ALERT SERVICE BULLETIN
Bell Helicopter **TEXTRON**

NO. 430-05-34

MODEL AFFECTED: 430

SUBJECT: NEW TRANSIENT LIMIT AND POWER TURBINE RPM (NP) STEADY STATE OPERATION AVOIDANCE, INTRODUCTION OF

Figure 2 – Instrument panel

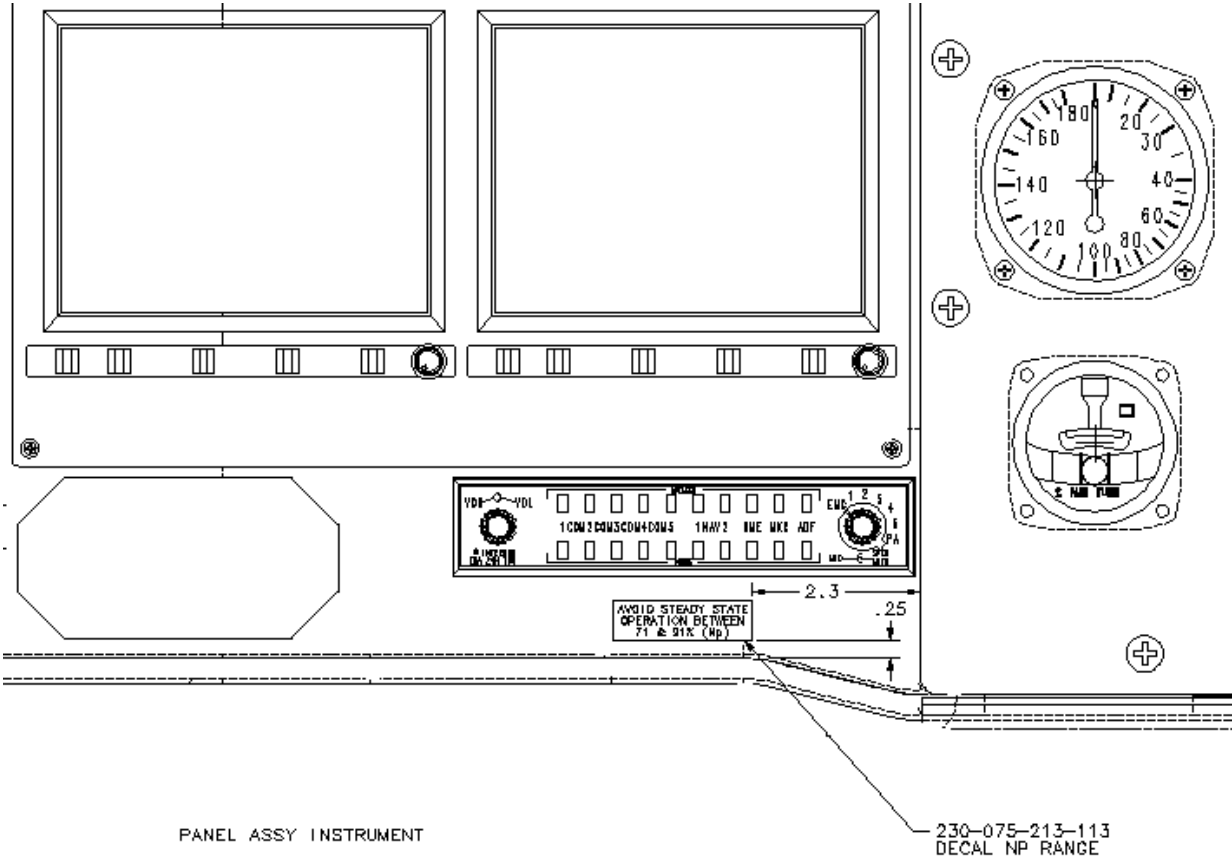
1. Comply with Rolls-Royce Corporation ALERT Commercial Engine Bulletin CEB A-72-5048 dated June 13,2005.
2. Following instructions in BHT-430-MM-2, Chapter 11, install decal 230-075-213-113, as shown in Figure 1, on the instrument panel. Refer to Figure 2 for location.
3. Insert the temporary Flight Manual revision (TR-15) dated May 6, 2005 into BHT-430-FM-1.
4. Annotate the aircraft technical records to indicate that this bulletin is completed.

Power Turbine Speed Restrictions
FIG. 1

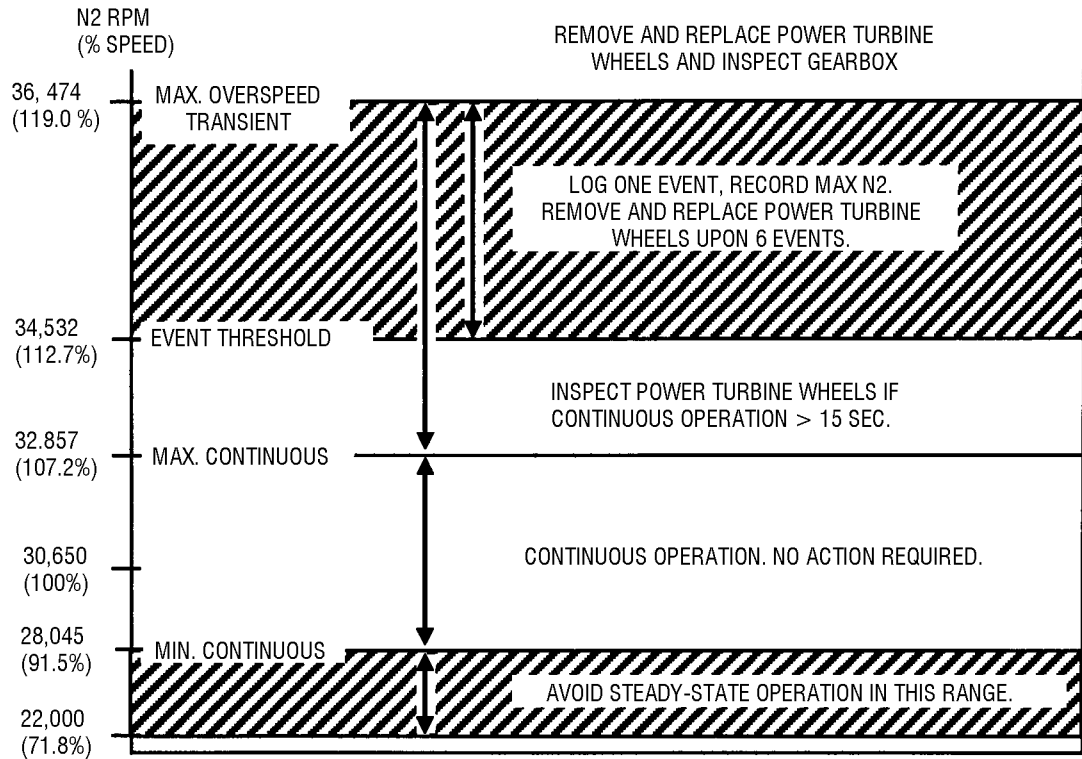
- (1) Transient overspeed excursions between the Max. Continuous line and the Max. Overspeed Transient line, which exceed 15 seconds require specific action as described in this CEB. Any excursion greater than 15 seconds requires power turbine wheel inspection.

- (2) The transient overspeed range is now divided into two sections. Any transient overspeed excursion above the Max. Continuous line and below the new Event Threshold line does not require maintenance action provided the single event is less than 15 seconds.

- (3) Any transient overspeed excursion above the new Event Threshold line and below the Max. Overspeed Transient line does not require maintenance action provided the single event is less than 15 seconds; however, the excursion shall be recorded as an event. No more than five events are allowed in this new range.

- (a) Maintain Engine Log Book Records so that transient N2 speed excursion events into the new range between 34,532 RPM (112.7% for the C30, C30G, C30M, C30P, C30R, C30R/1, C30R/3, C30R/3M, C30S, C30U and C47M; 112.4% for the C30G/2; 107.3% for the C47B; and 111.7% for the C40B) and 36,474 RPM (119.0% for the C30, C30G, C30M, C30P, C30R, C30R/1, C30R/3, C30R/3M, C30S, C30U, and C47M; 118.7% for the C30G/2; 113.3% for the C47B; and 118.0% for the C40B) are recorded. Record the maximum speed exceedance value and the date in the Life Limited Part Log Card.

Power Turbine Speed Restrictions
FIG. 4

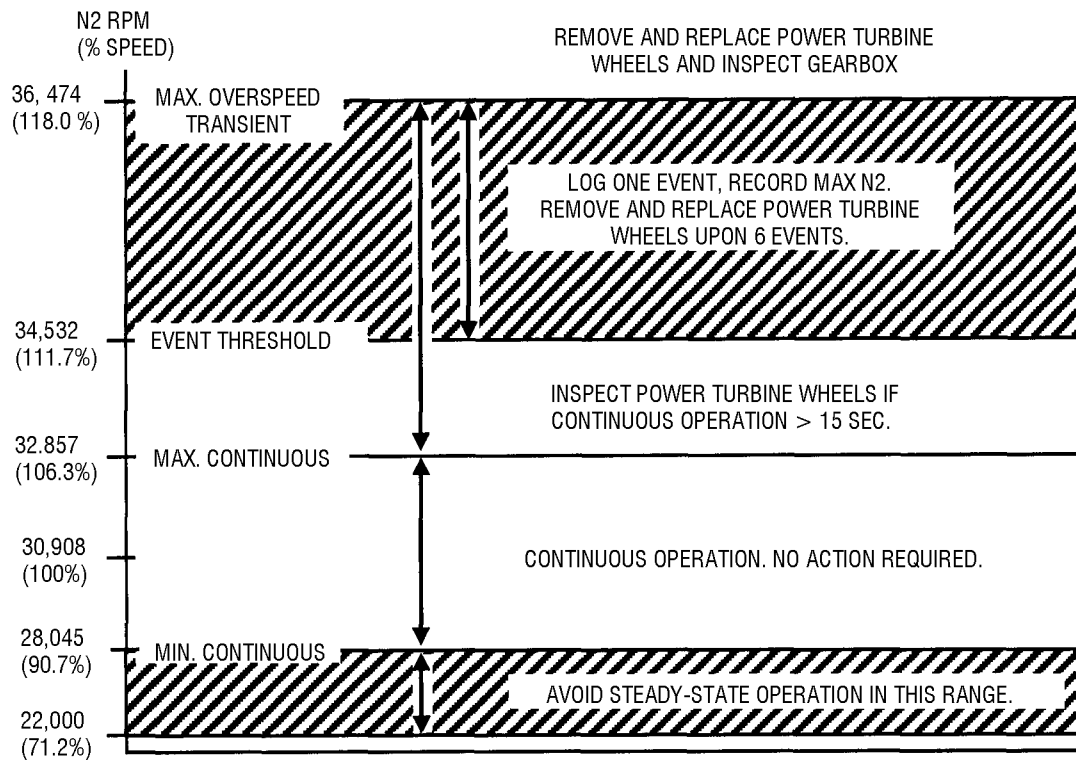
With the release of CEB A-72-5048, Rolls Royce has revised the Model 250-C40B Engine Overspeed Limit Table introducing a new Steady State Operation Avoidance Power Turbine RPM (Np) Speed range between 71% and 91%. A decal is added on the instrument panel to ensure crew awareness of this new Np speed restriction.
